144 FERC ¶ 61,057
UNITED STATES OF AMERICA
FEDERAL ENERGY REGULATORY COMMISSION

[Docket No. RM13-11-000]

Frequency Response and Frequency Bias Setting Reliability Standard

ACTION: Notice of proposed rulemaking.

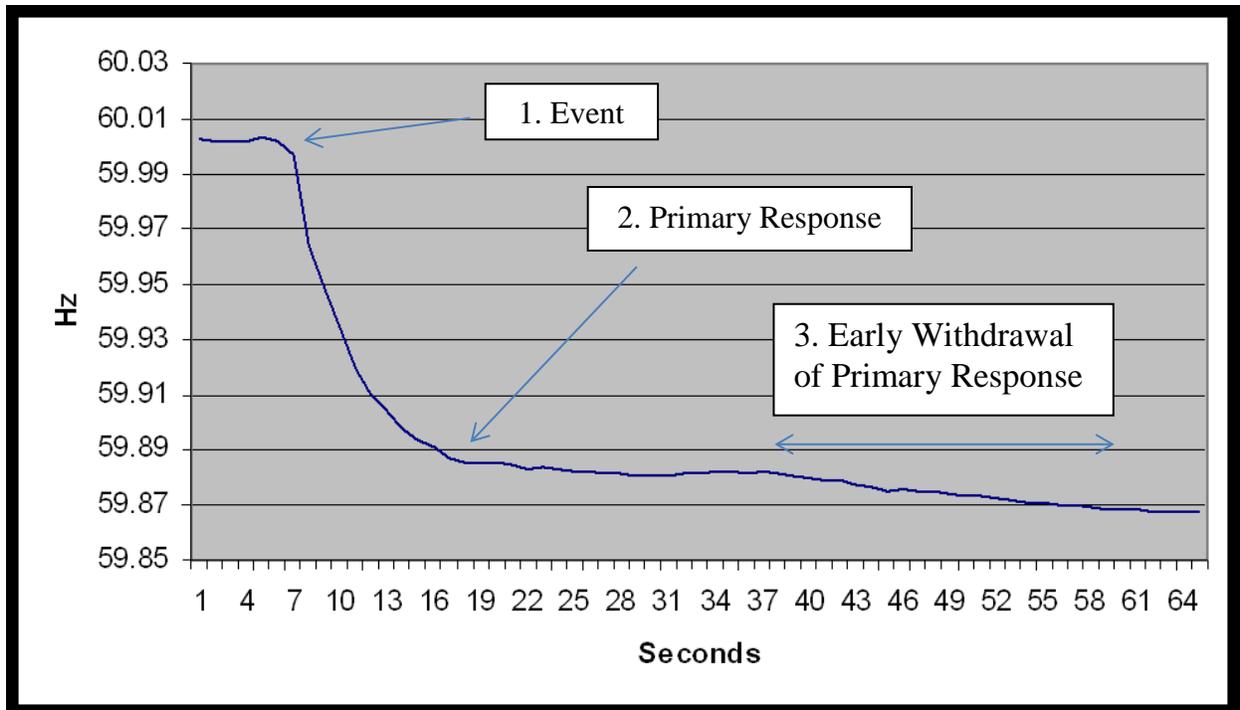
35. As explained above, following the sudden loss of generation, the automatic and immediate increase in power output by resources providing primary frequency control seeks to quickly arrest and stabilize the frequency of the interconnection, usually within 30 seconds or less. After this rapid primary frequency response, AGC provides secondary frequency response to return frequency to the scheduled value in time frames of several minutes after the loss of generation. If a significant amount of primary frequency response is withdrawn before the secondary frequency response is activated, a

further drop in frequency response will occur. This drop in frequency is illustrated by the following diagram:⁵³

36. NERC indicates that, while the standards drafting team addressed the early withdrawal of primary frequency response, there are no requirements that address this issue and it remains a concern.⁵⁴ Specifically, during the initial recovery from the loss of a generator, a “gap” can occur if significant amounts of primary frequency responses are

withdrawn before the secondary response is fully activated. As previously noted, the Interconnection Frequency Response Obligation for each Interconnection is a function of the resource contingency criteria and the maximum change in frequency.⁵⁵ The Frequency Response Initiative Report recommends that an adjustment should be made to the maximum allowable change in frequency to compensate for the predominate withdrawal of primary frequency response exhibited in an Interconnection until such withdrawal is no longer exhibited.⁵⁶ NERC includes an adjustment to provide an additional primary frequency response when early withdrawal of primary frequency response would occur.⁵⁷ This adjustment only partially addresses the concern because, while increased primary frequency response is beneficial, it still does not address early withdrawal of primary frequency response that otherwise would allow time for secondary frequency response to prevent further decline in frequency. The Frequency Response Initiative Report also recommends that this adjustment should be carefully monitored and recalculated during the annual Interconnection Frequency Response Obligation calculations.⁵⁸ The Frequency Response Initiative Report notes that there are potential

38. We are concerned that proposed Reliability Standard BAL-003-1 does not adequately address the reliability issue associated with the withdrawal of primary frequency response prior to activation of secondary frequency response. The premature withdrawal of primary frequency response absent activation of resources providing

secondary frequency response may lead to under-frequency load shed and possible cascading outages. Accordingly, we propose to direct that NERC develop a modification to BAL-003-1 to address the concern of premature withdrawal of frequency response prior to the activation of secondary frequency response.
